**Fort Street Public School (SSD-10340)**

**Additional Safety Protection Structures on the Trafficable Rooftops, Conditions E20, A15**

Fort Street Public School  
Building H + J Rooftop and MET Rooftop Balustrade Upgrade  
Proposal

# Building J/H Rooftop and MET rooftop Balustrade Upgrade

3 ELEVATION SOUTH  
1:100

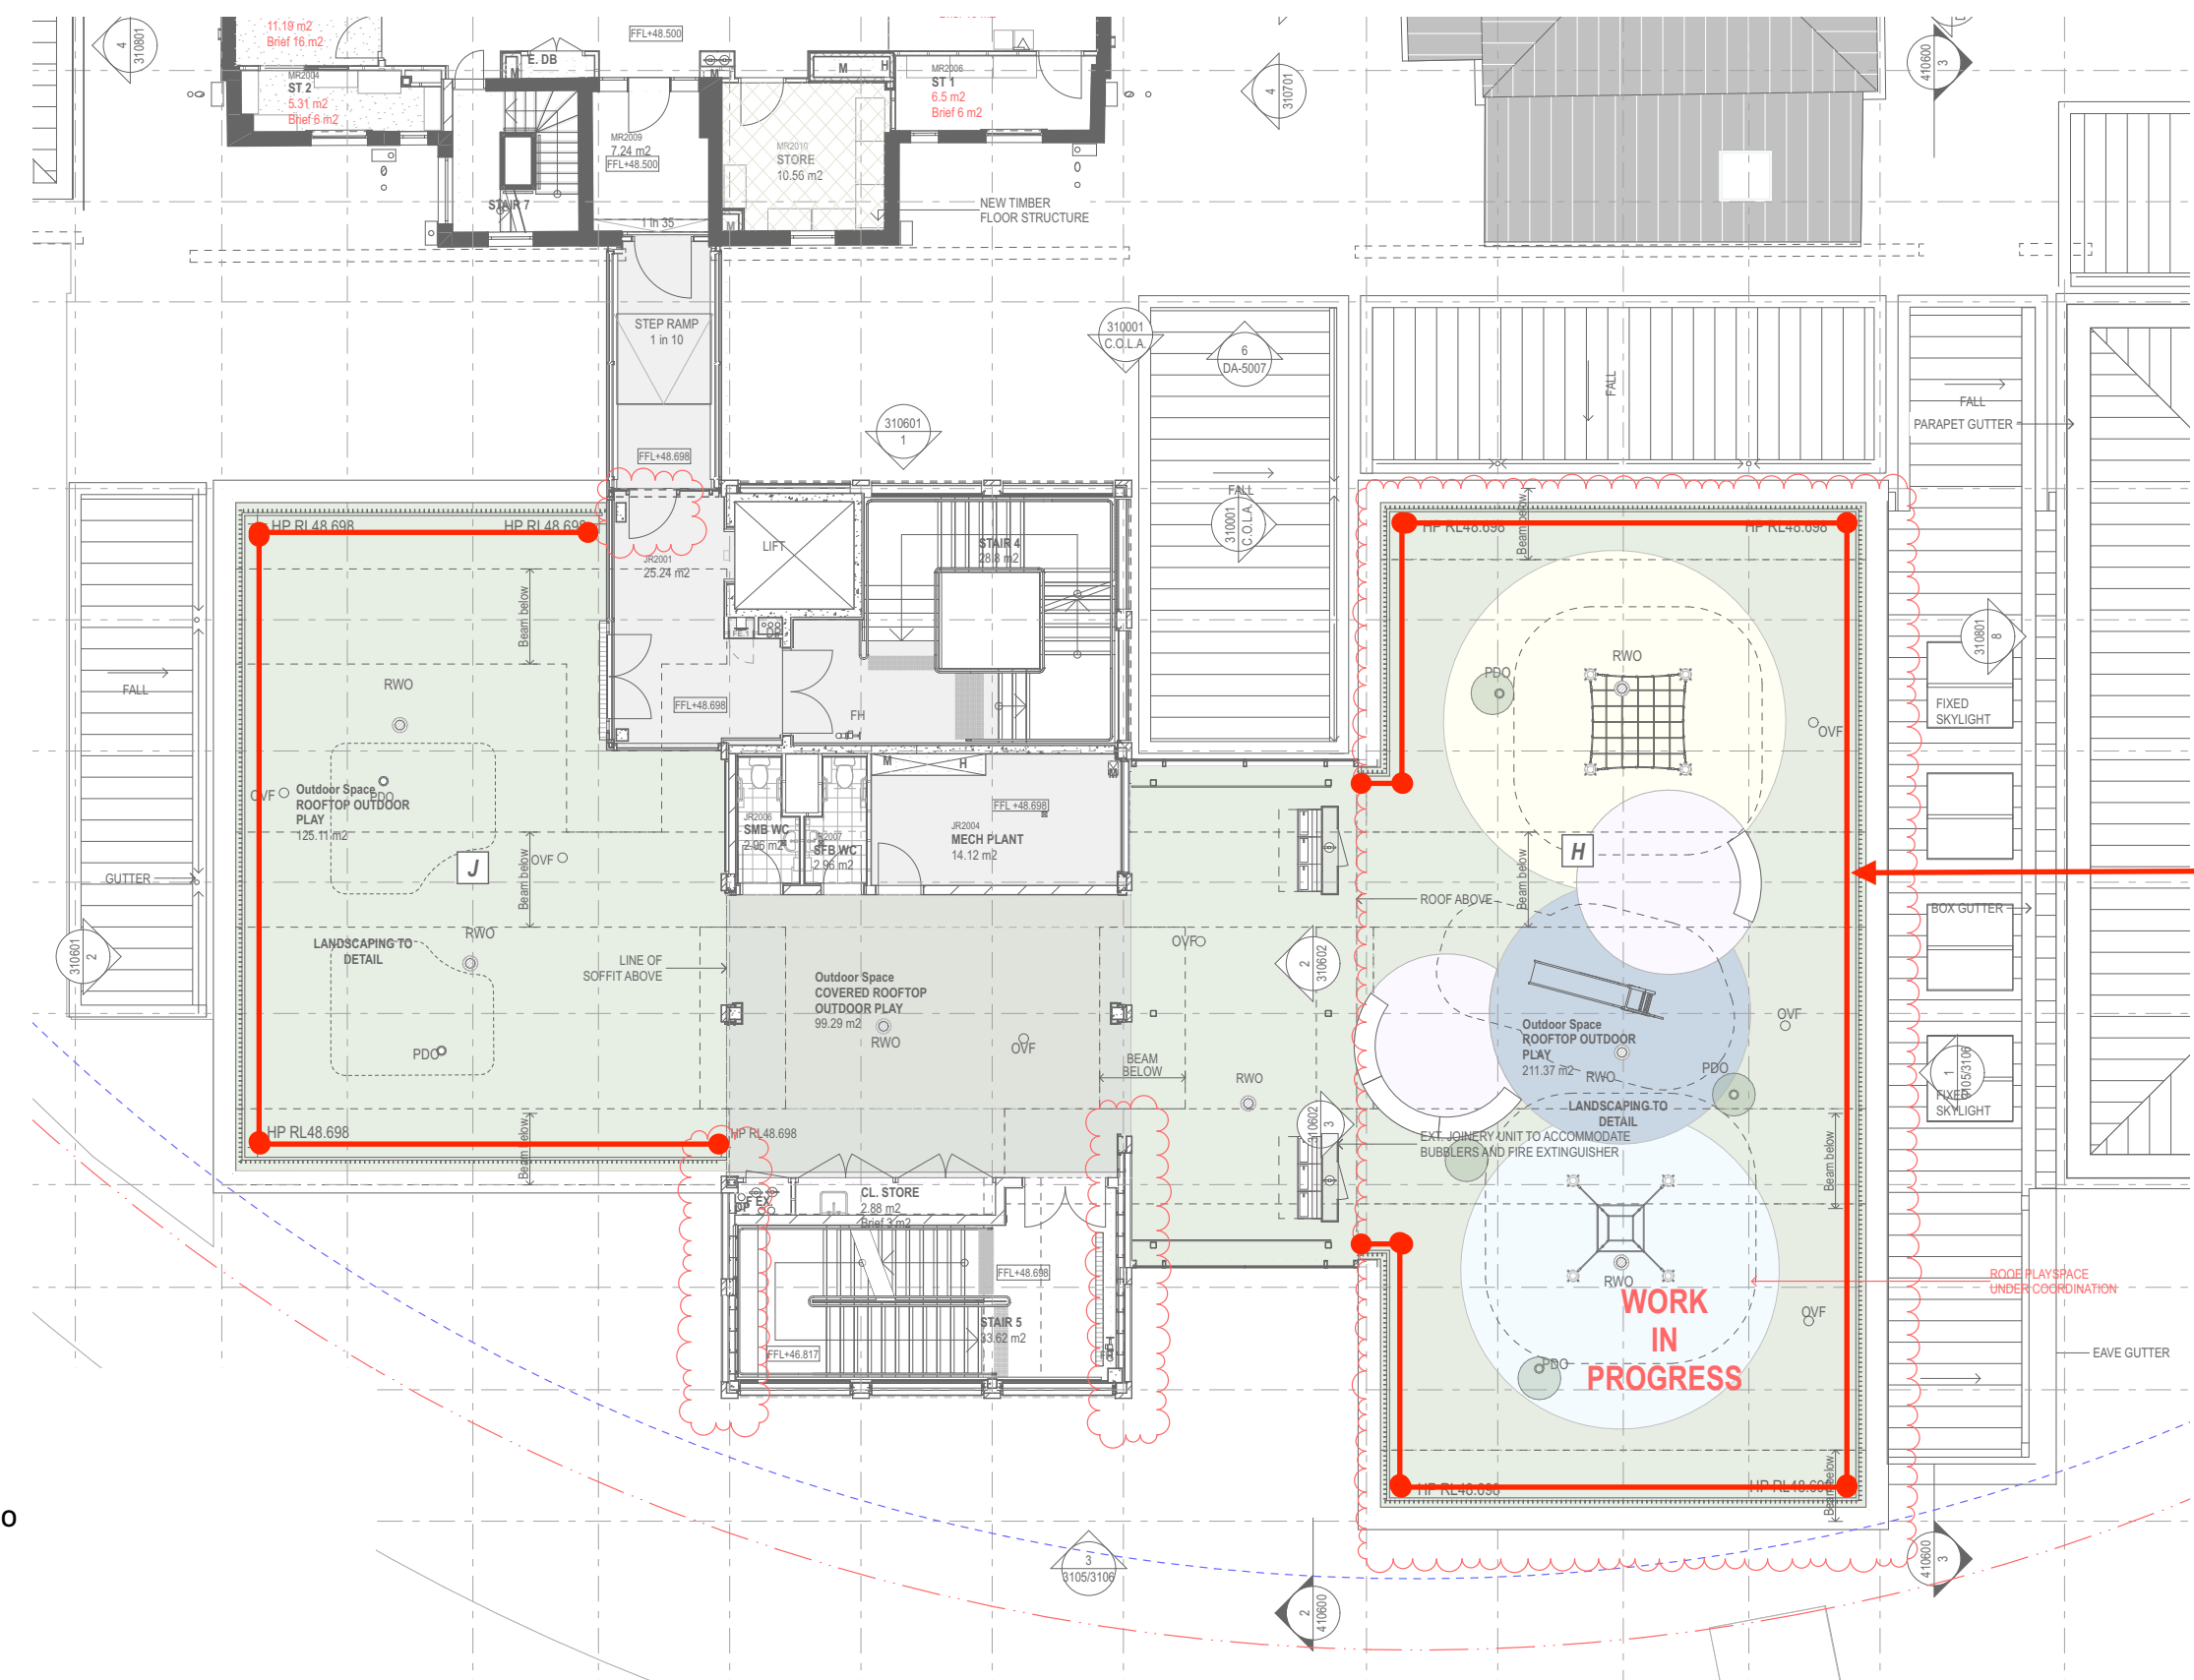
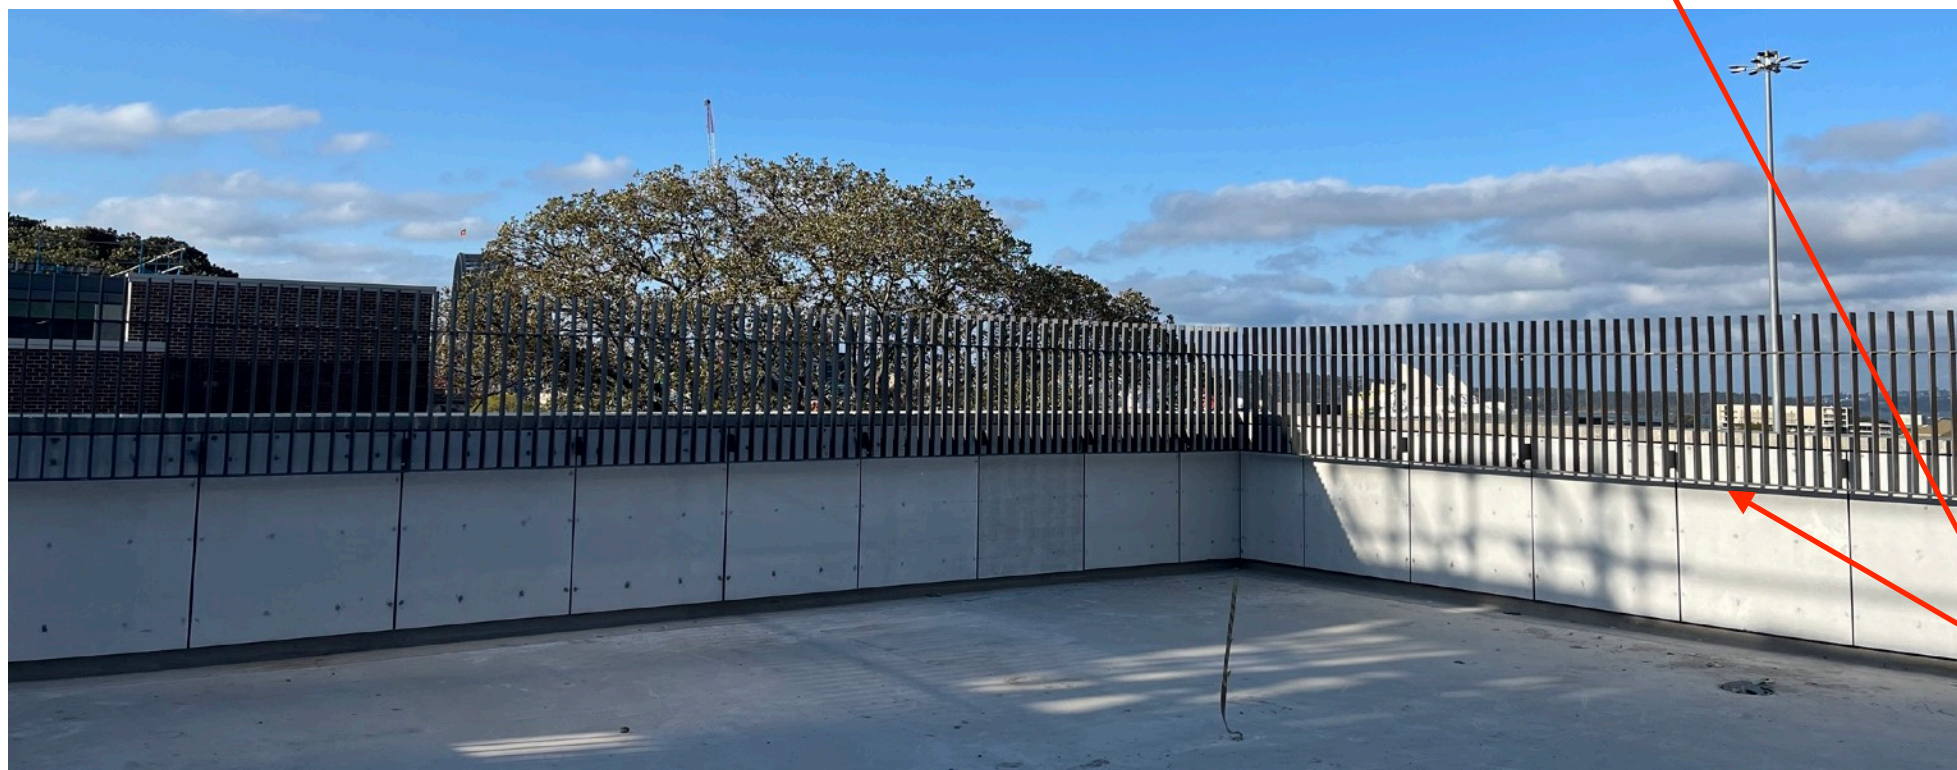
extent of BAL08 balustrade

address bottom rail to remove climbing risk

3 ELEVATION South - Building M  
1:50

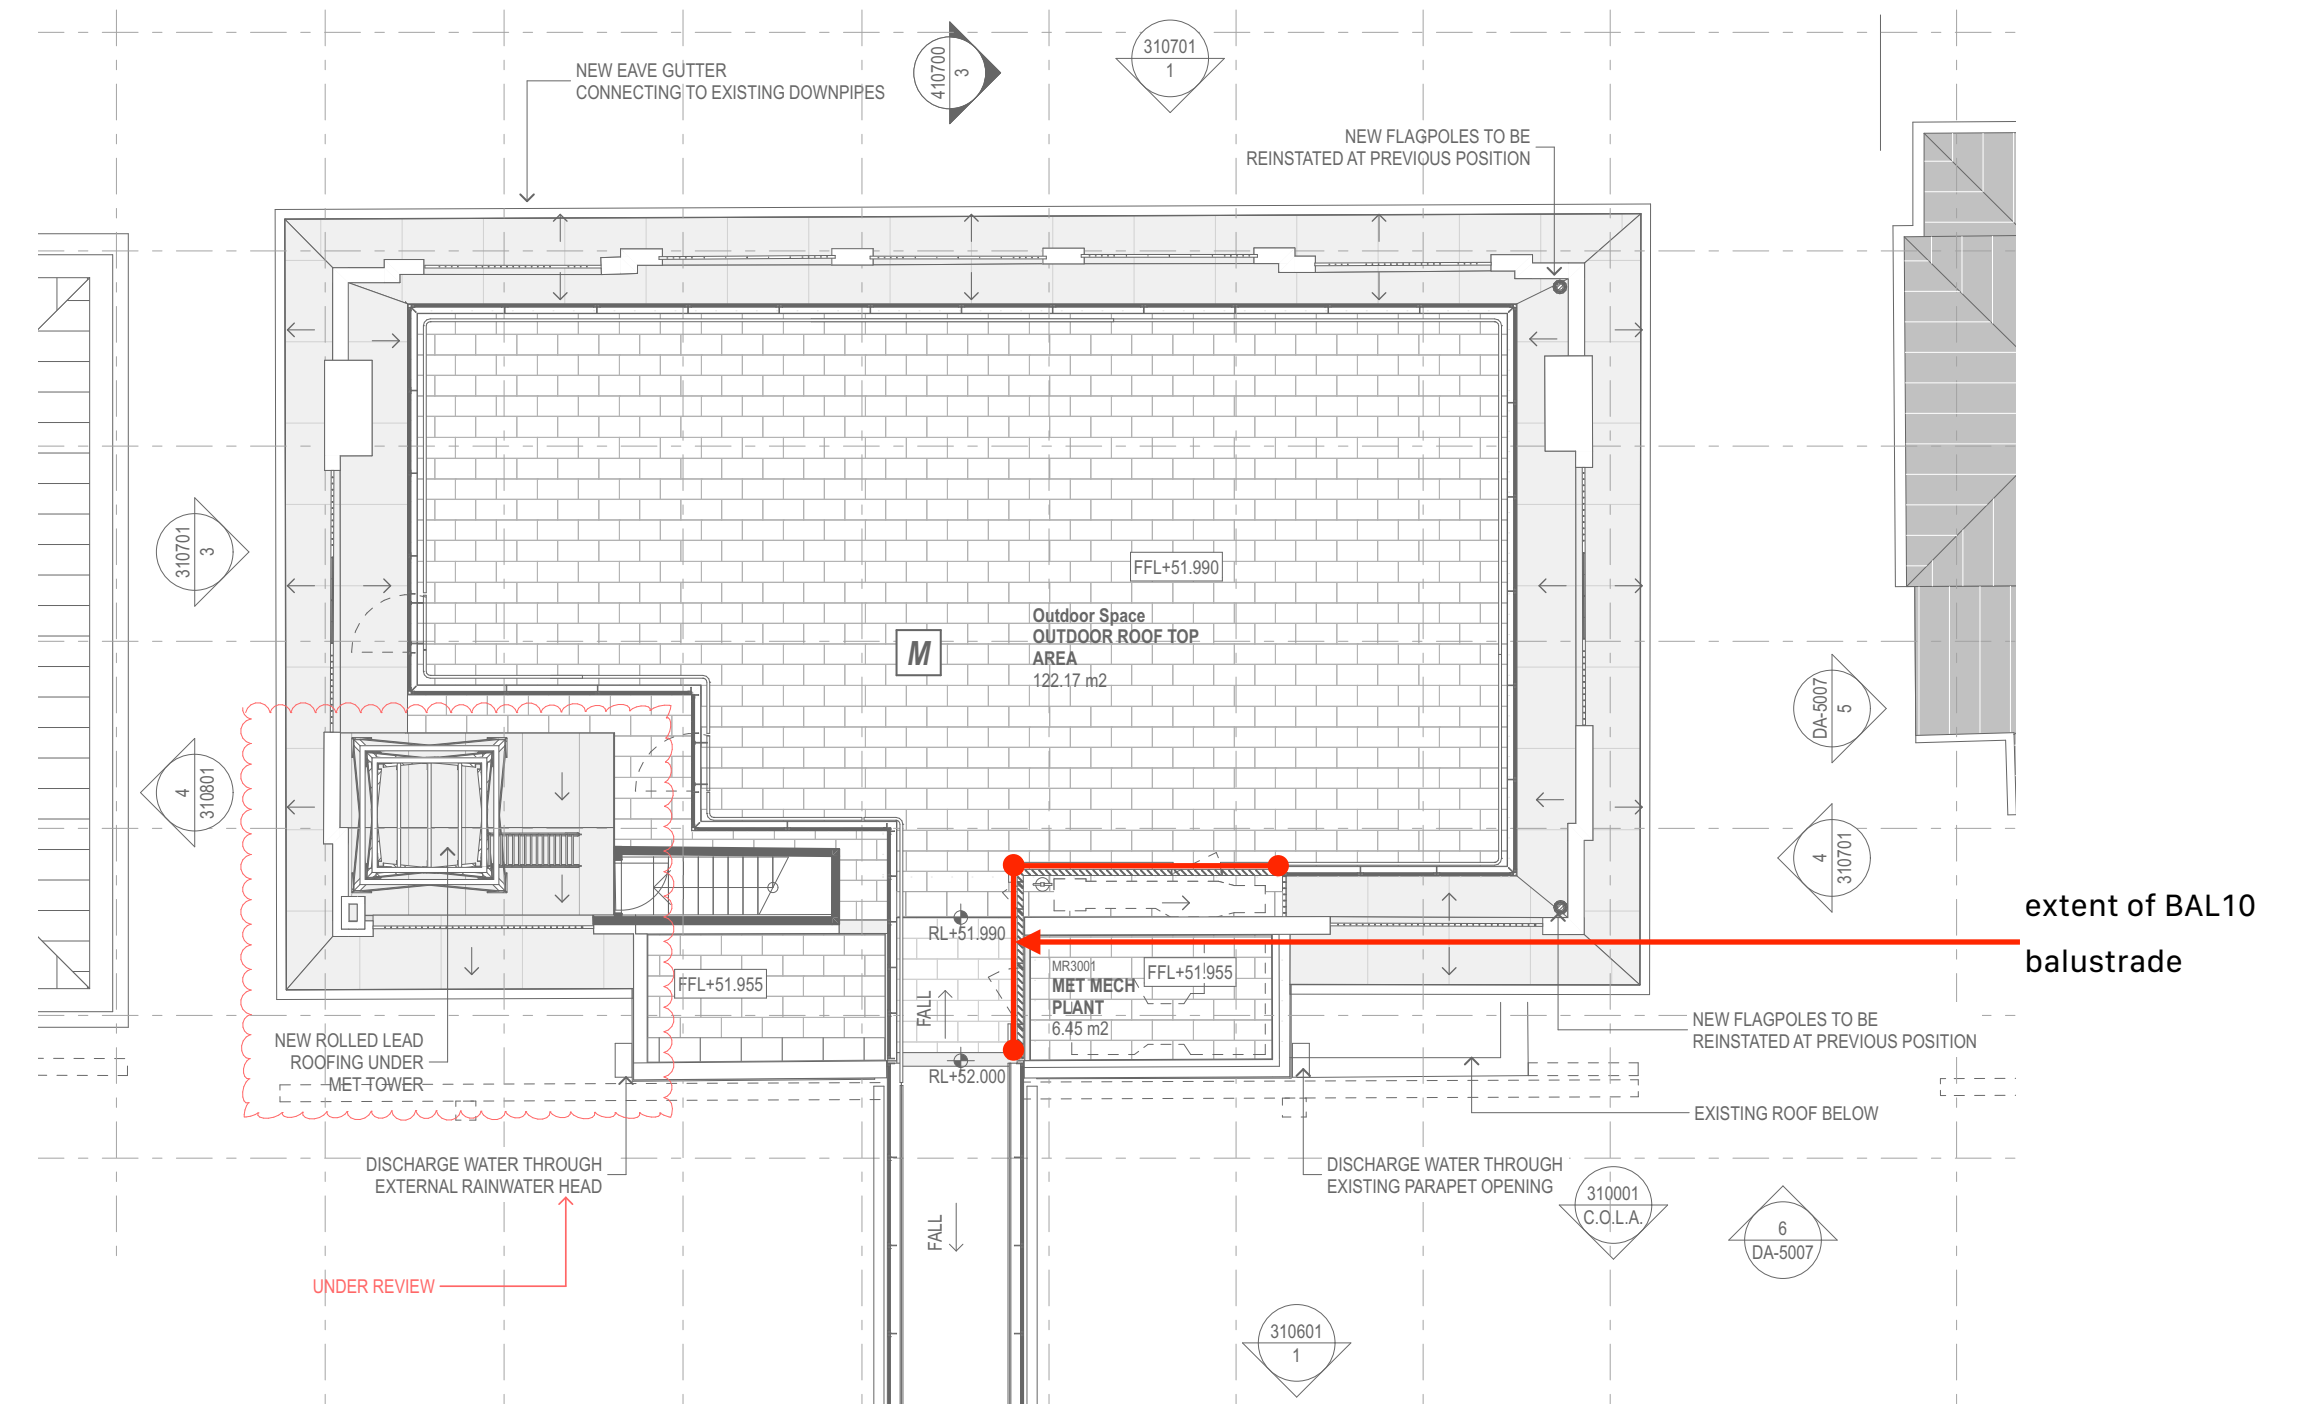
address bottom rail to  
remove climbing risk
